ADDENDUM NO. 03

Project: Wastewater Treatment Facility Improvements
Walnut Ridge, Arkansas

The Contract Documents dated February 3, 2021, are hereby amended as follows:

Wastewater Treatment Facility Improvements

WALNUT RIDGE, ARKANSAS		J
WASTEWATER TREATMENT FACILITY IMPROVEMENTS		
ADDENDUM #3		S
SBR 01 MECHANICAL PLAN AND SECTIONS

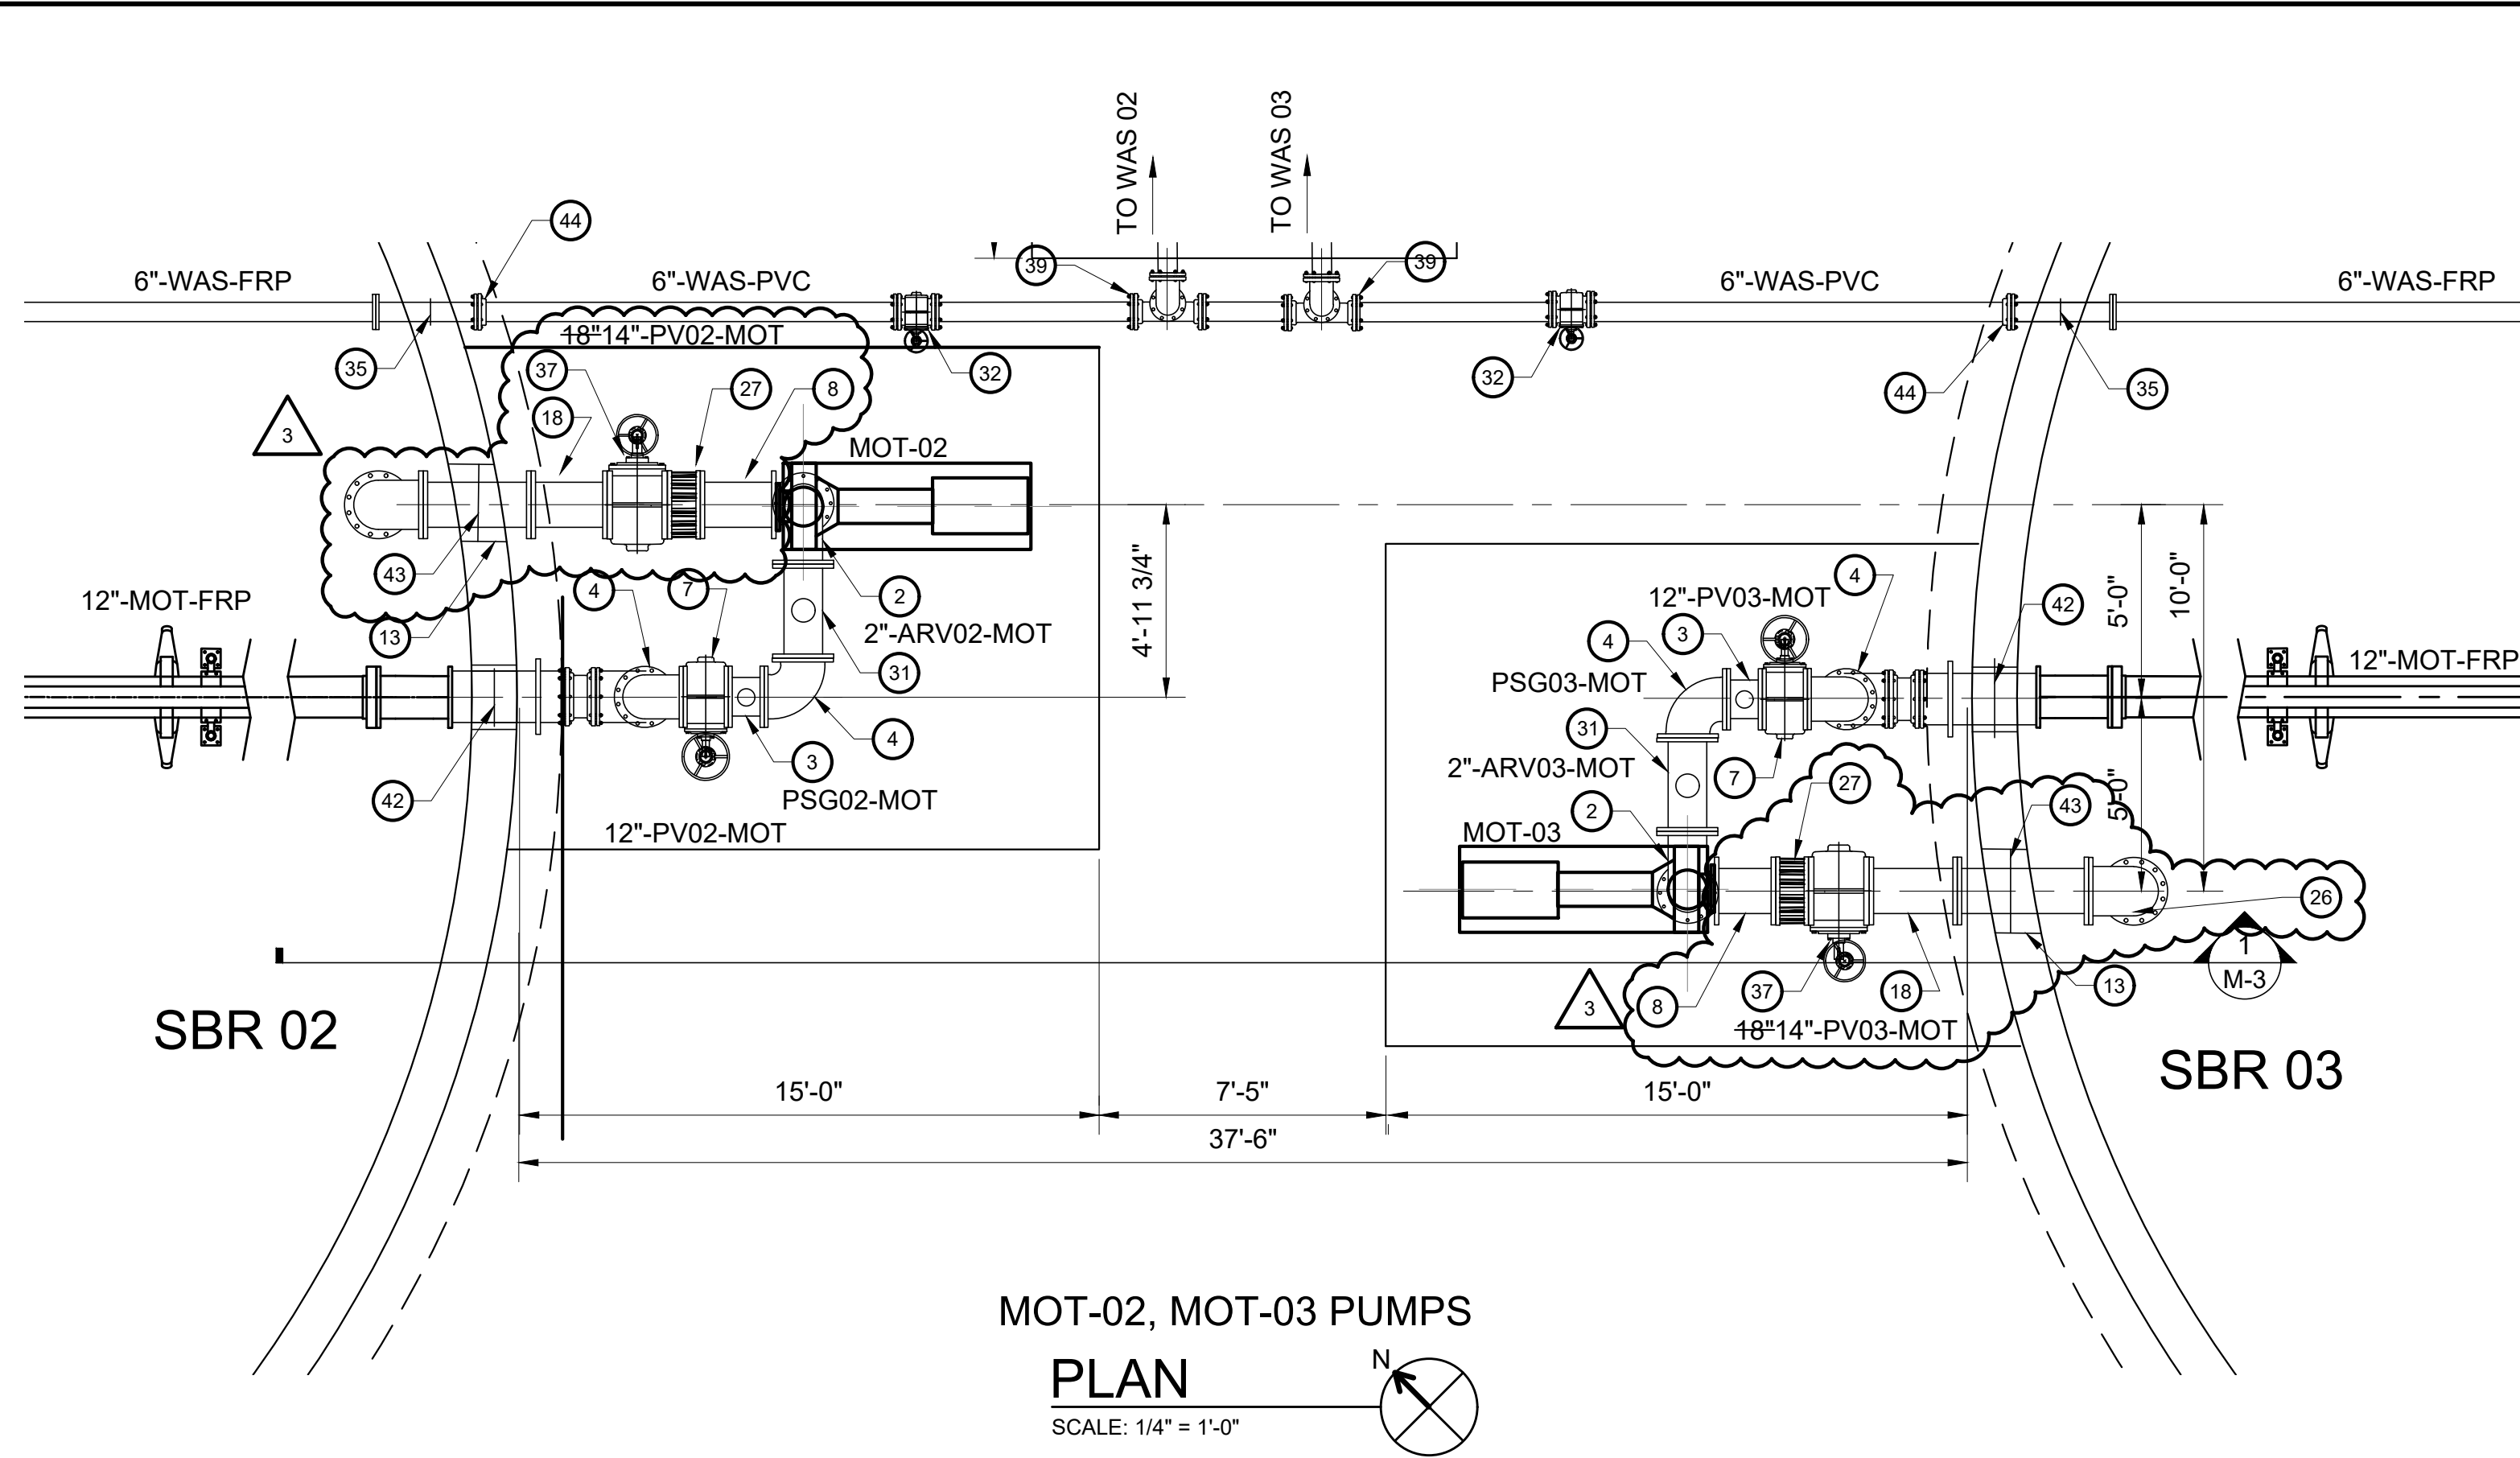
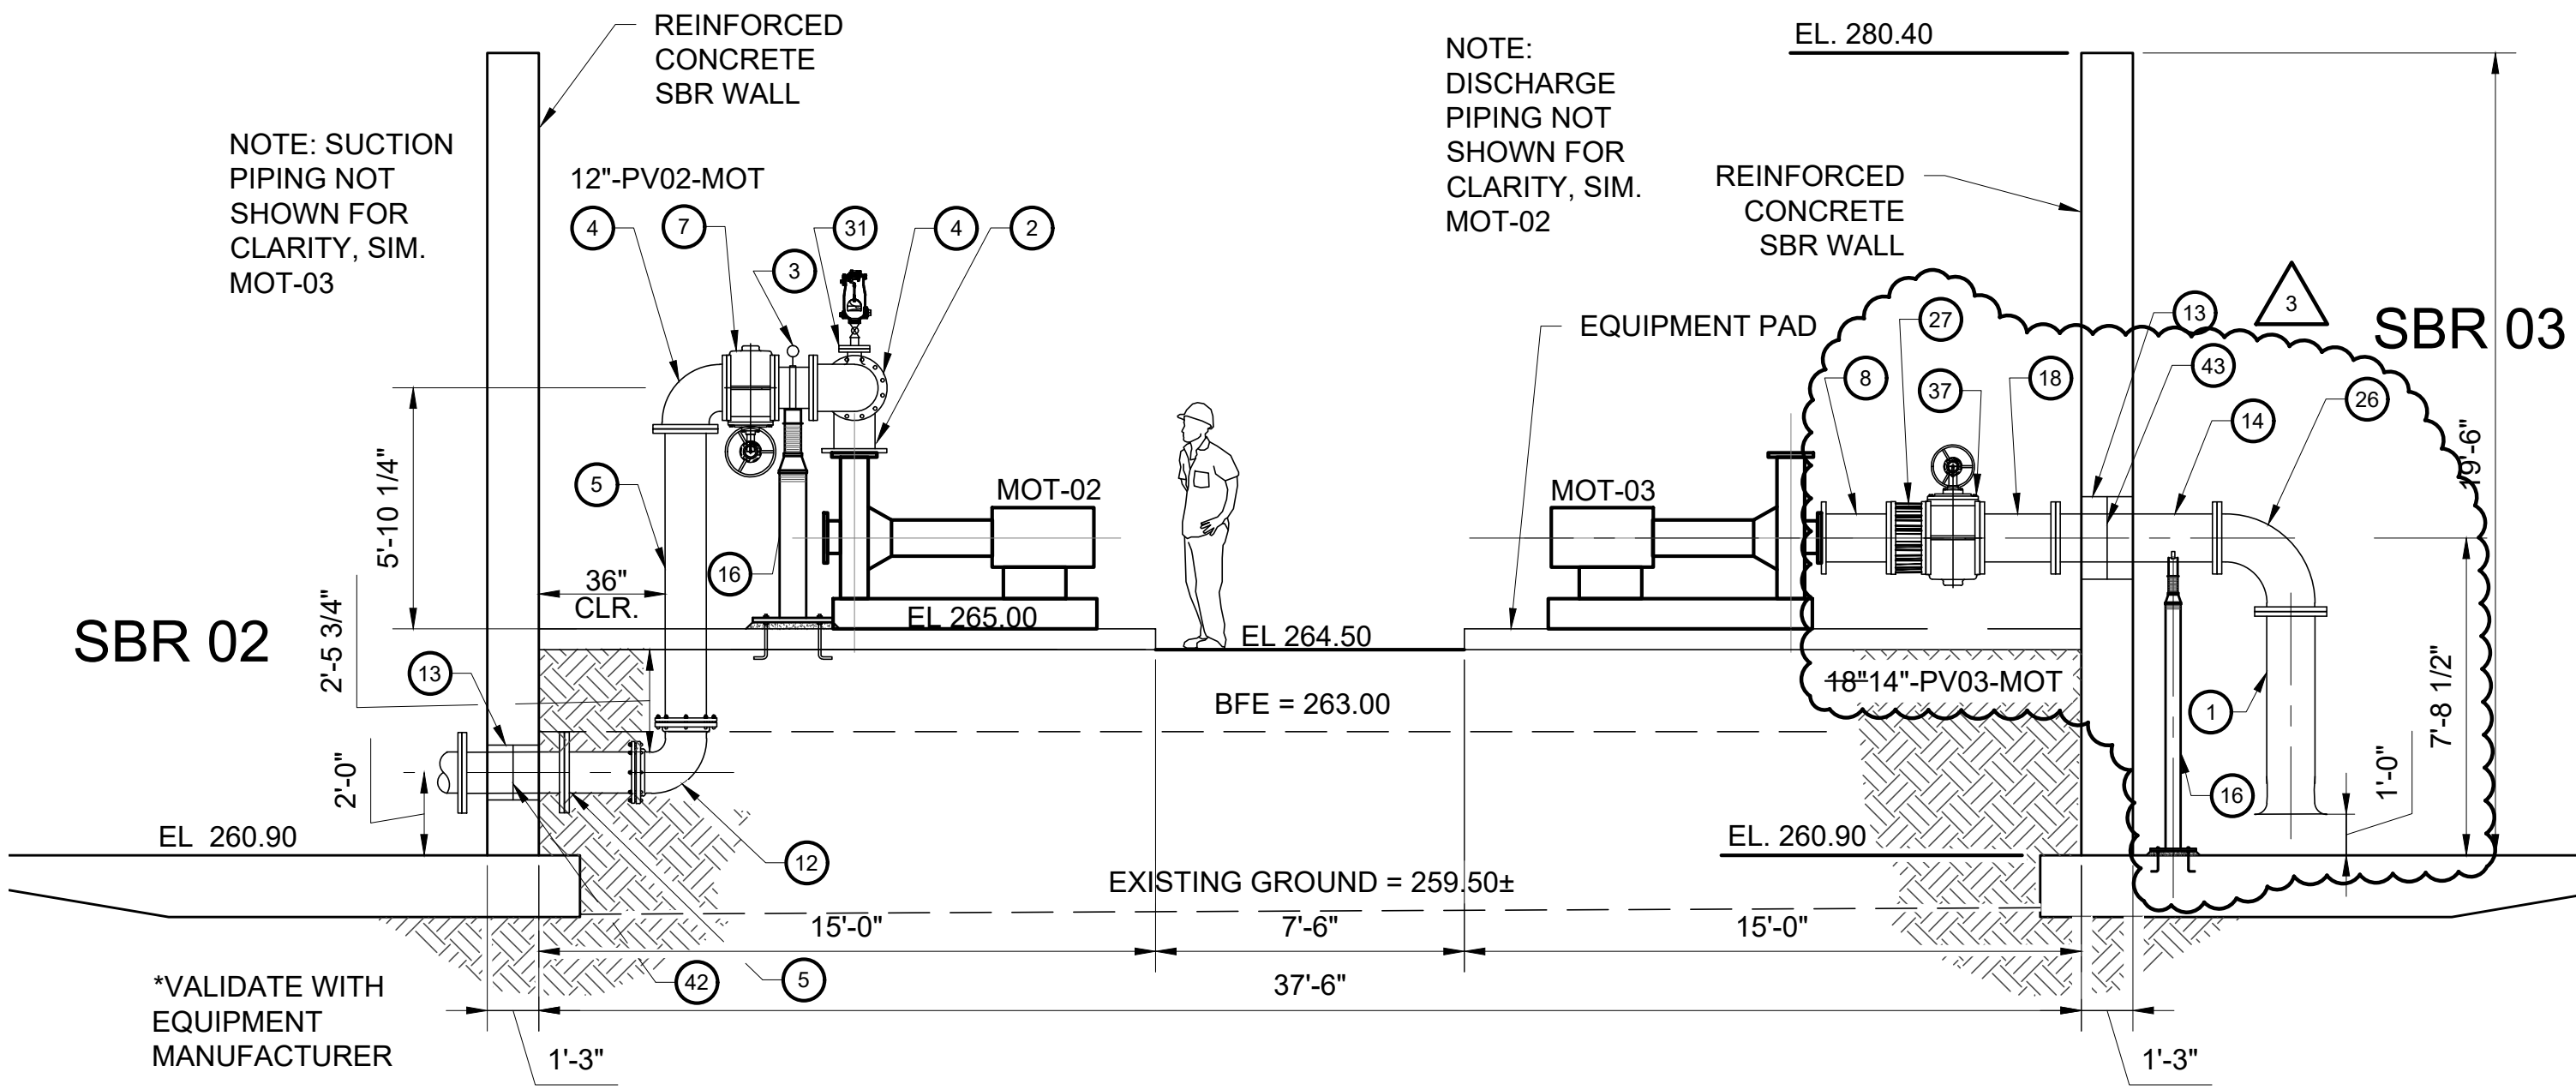
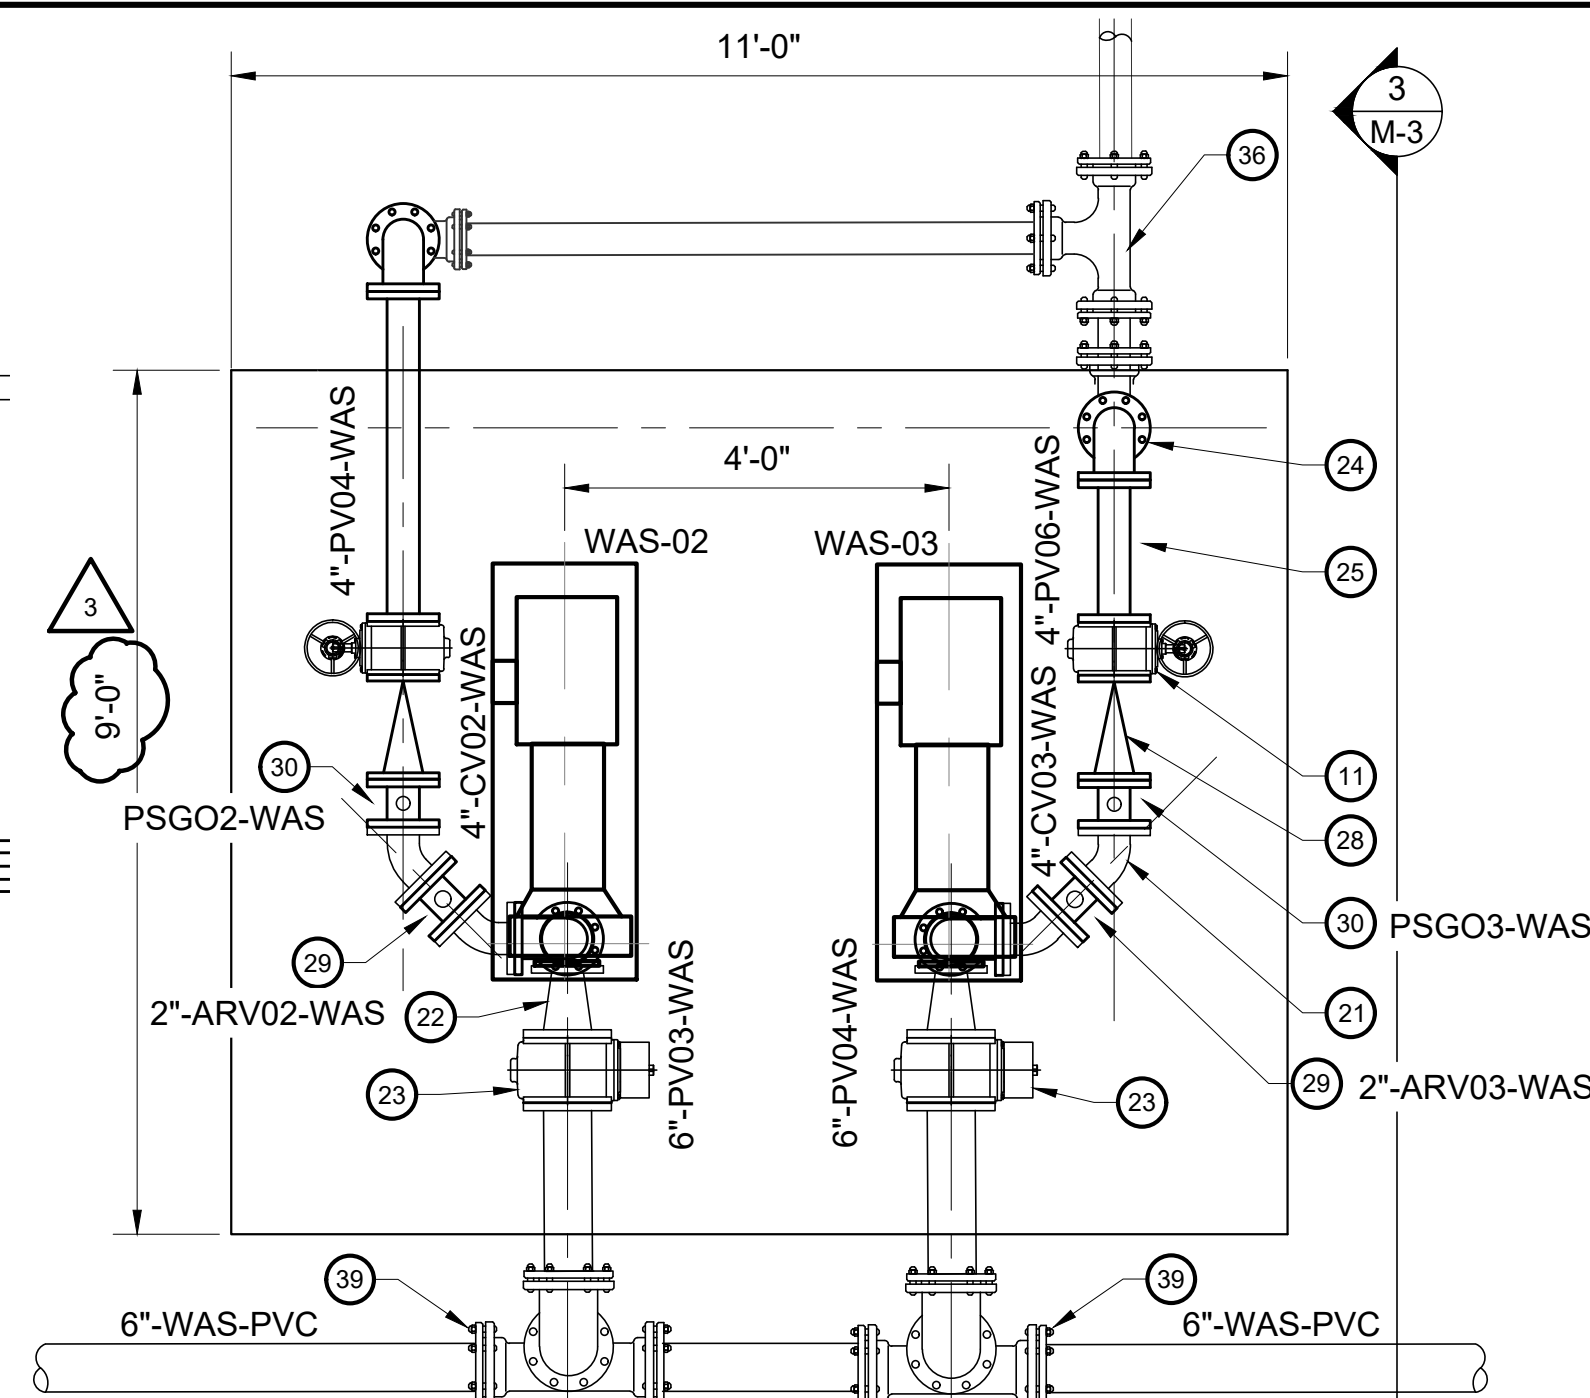
13. Drawing M-2 – SBR 01 Mechanical Plan and Sections:

- a. Modify this drawing as shown on the Addendum No. 3 – SBR 01 Mechanical Plan and Sections, attached hereto.
